Revised Intake Manifold Gasket For 1989-97 Rover 4.0L Engines

The AERA Technical Committee offers the following information regarding a revised intake manifold gasket for 1989-97 Rover 4.0L engines. This information applies to engines built within the VIN codes listed below:

Figure 2
Intake Manifold Bolt Torque Sequence

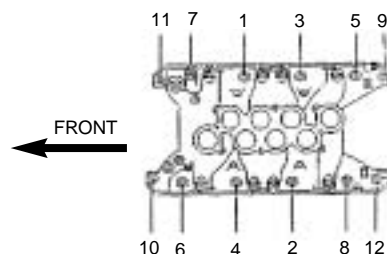
The gasket design change can be easily identified as a change in the shape of the gasket around each inlet and coolant port opening. The installation of the new parts requires the correct torque procedure and must be followed with the new style gasket and flat washers. Please refer to the numbered sequence in Figure 2 to torque the mounting bolts.

1. Tighten clamp bolts at front and rear of gasket to 4-7 ft/lbs (5-10 Nm). **CAUTION:** A flat washer must be used beneath all 12-bolt heads to ensure correct pressure being applied.
2. Tighten the twelve intake manifold to cylinder head bolts in sequence (Figure 2) to 21 ft/lbs (30 Nm).
3. **WAIT!** Allow gasket to bed in (set up) for at least 5 minutes.
4. Tighten the twelve intake manifold to cylinder head bolts in sequence (Figure 2) to 35-40 ft/lbs (47-54 Nm) using a standard torque wrench.
5. Tighten clamp bolts at front and rear of gasket to 10-15 ft/lbs (14-20 Nm).
